Architect's Supplemental Instructions

Architect's ASI No: 043

Project:
Webster University
Interdisciplinary Science
Building

Date Issued: 12/20/2016

M0502

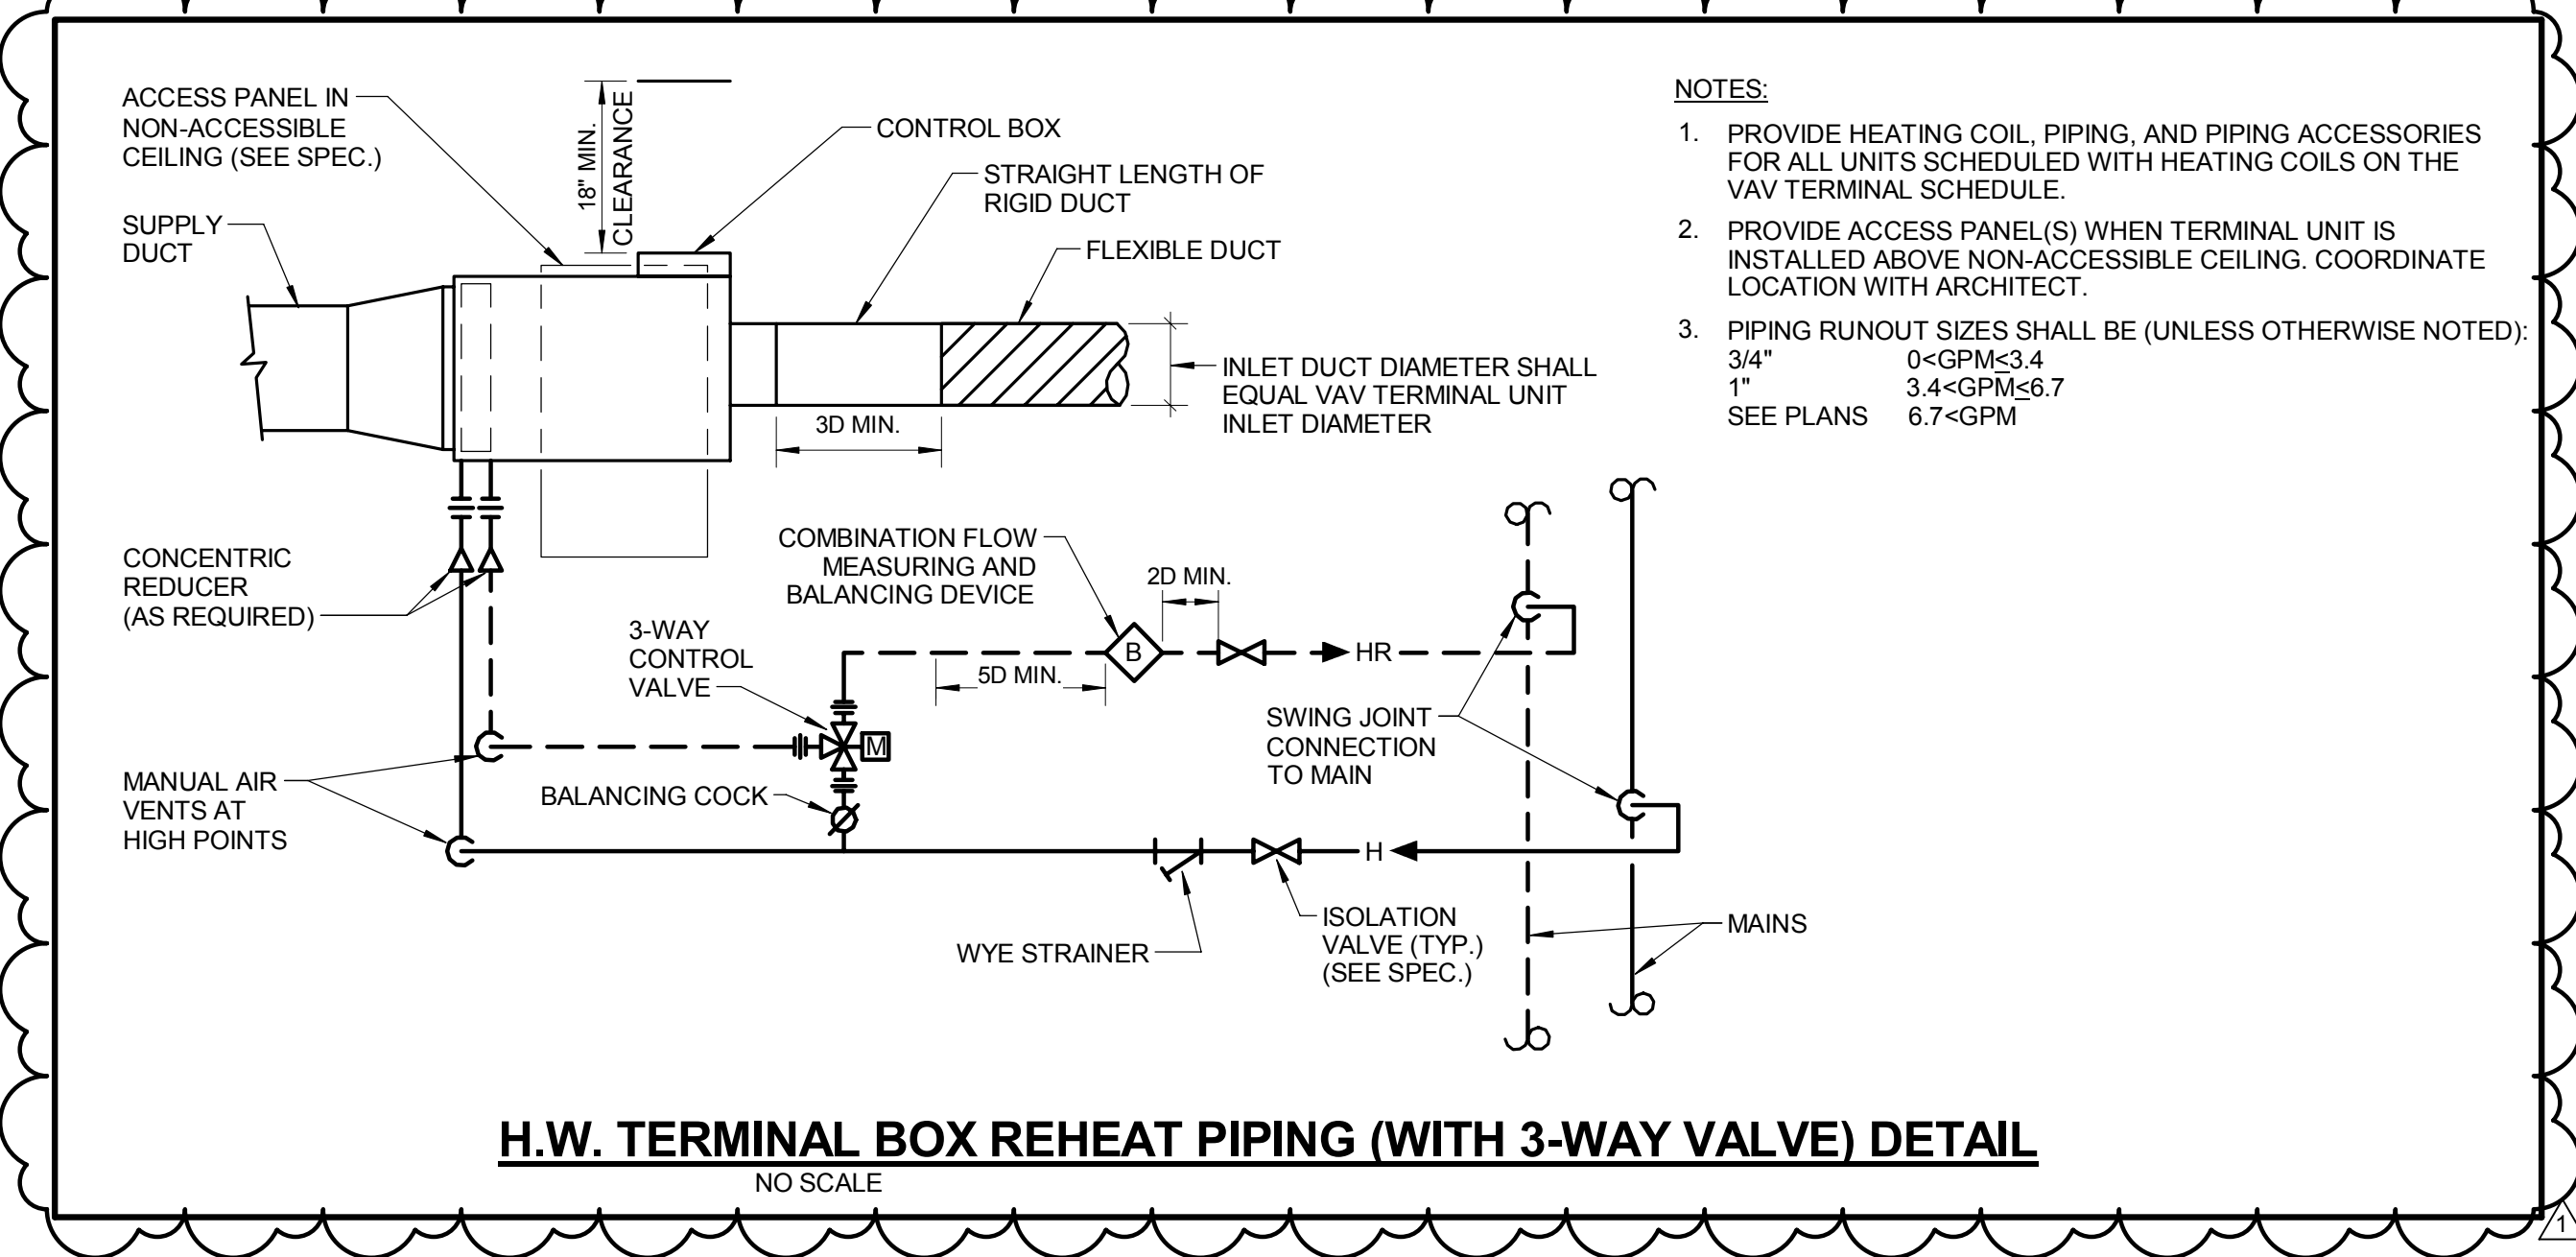
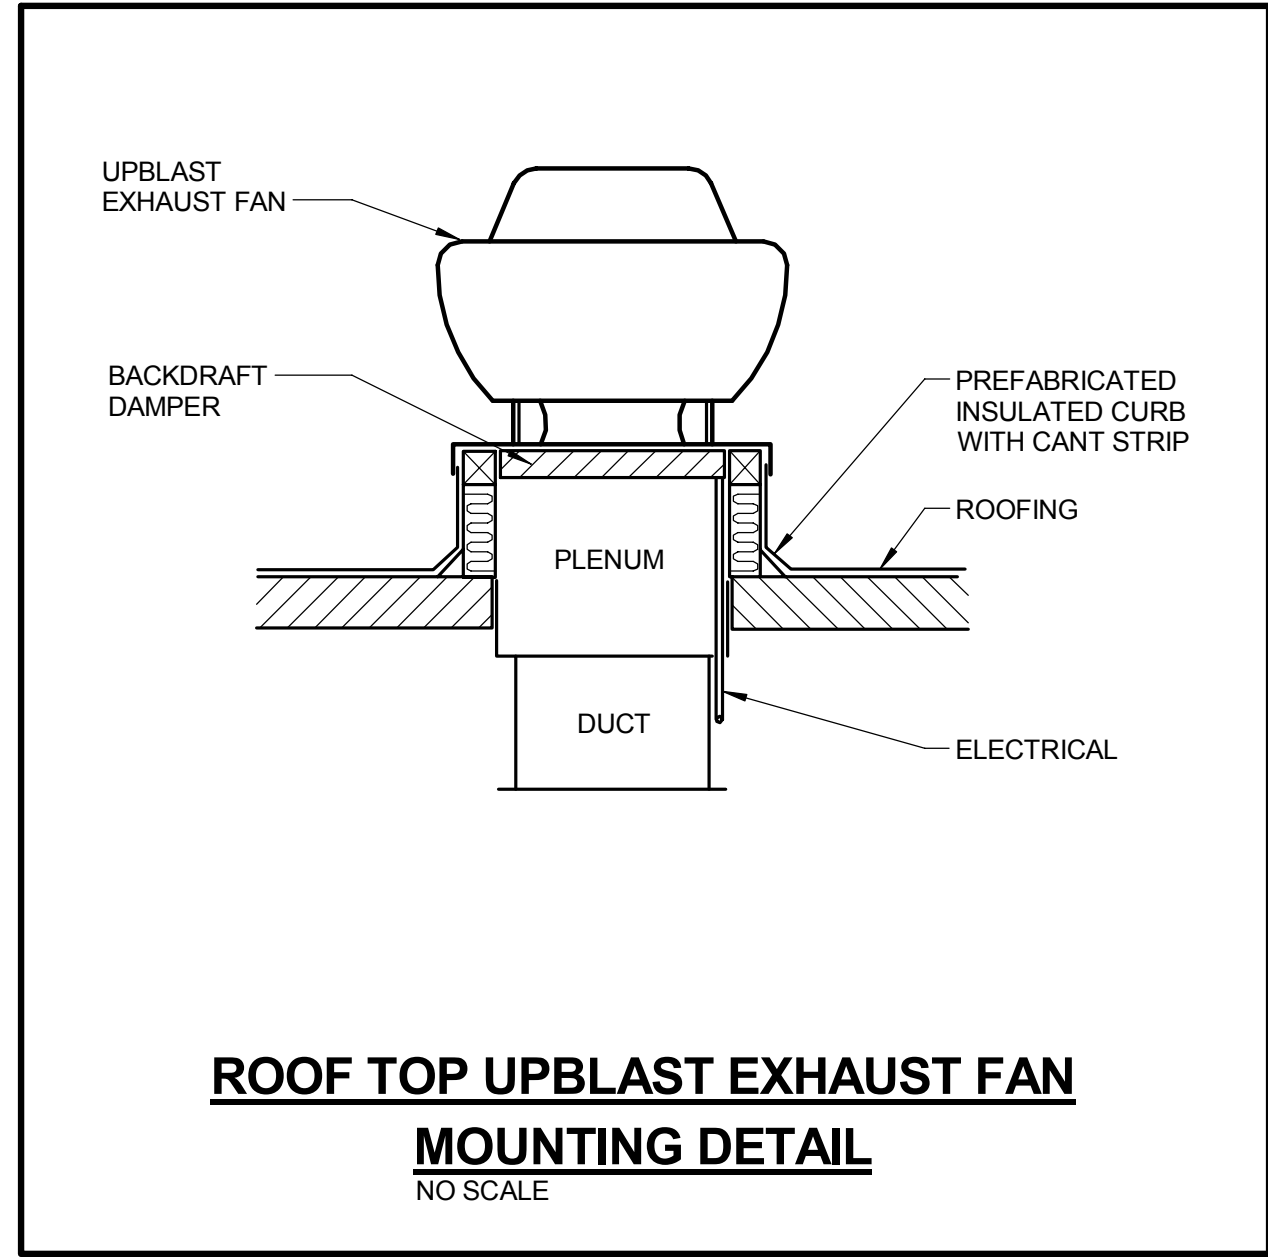
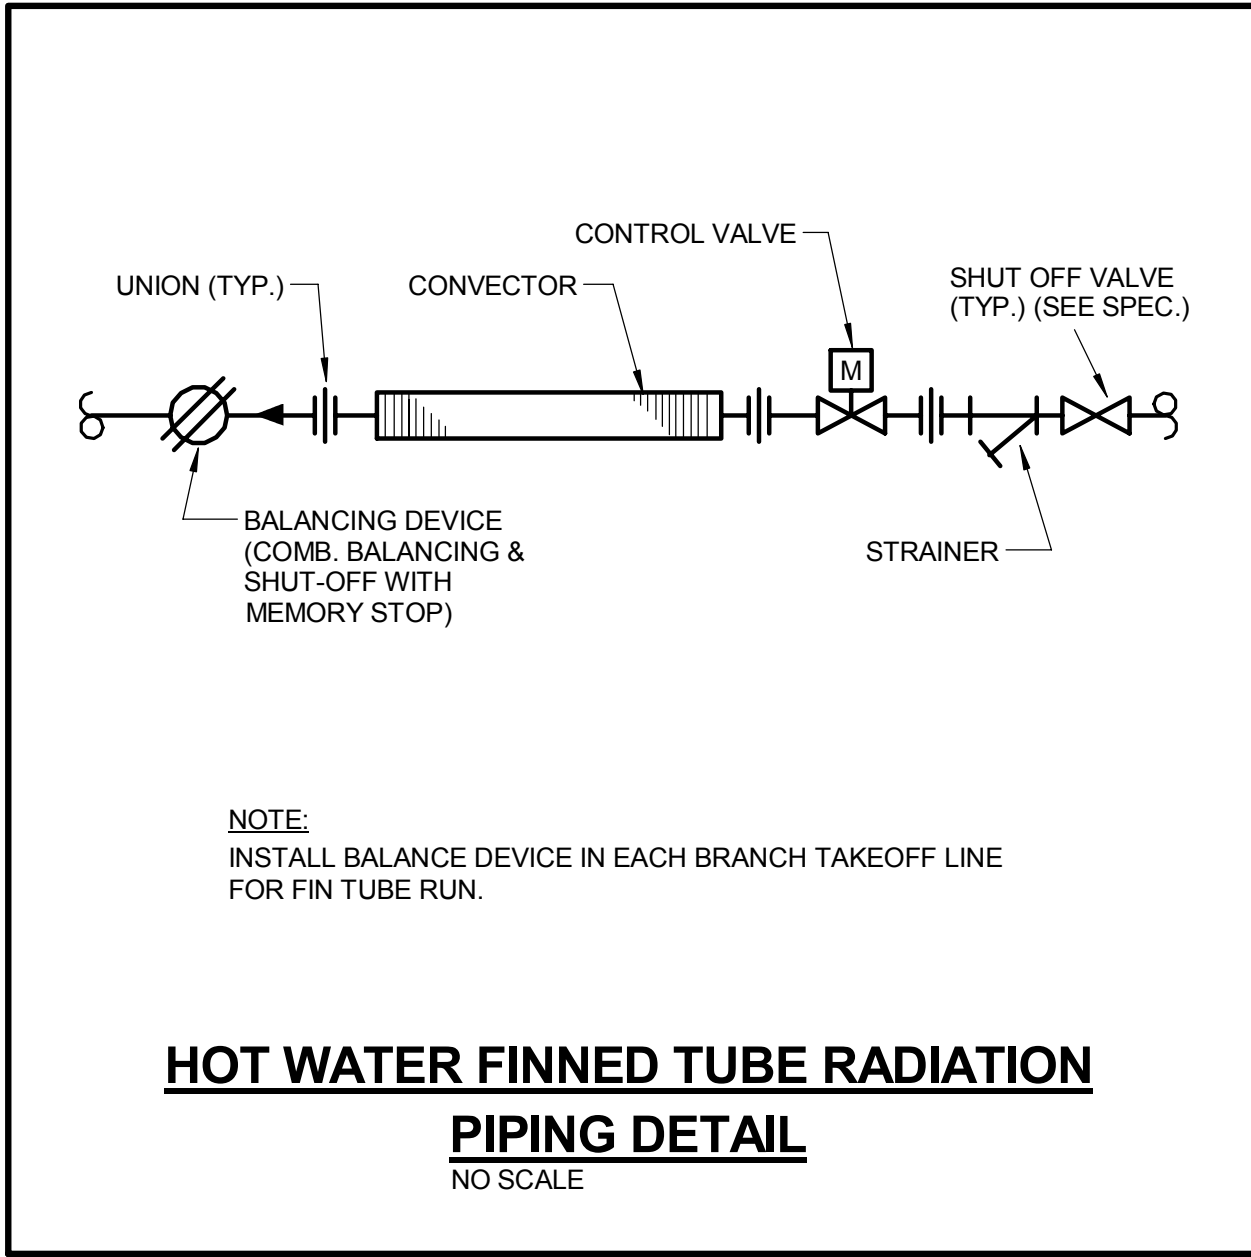
- Add H.W. TERMINAL BOX REHEAT PIPING (WITH 3-WAY VALVE) DETAIL
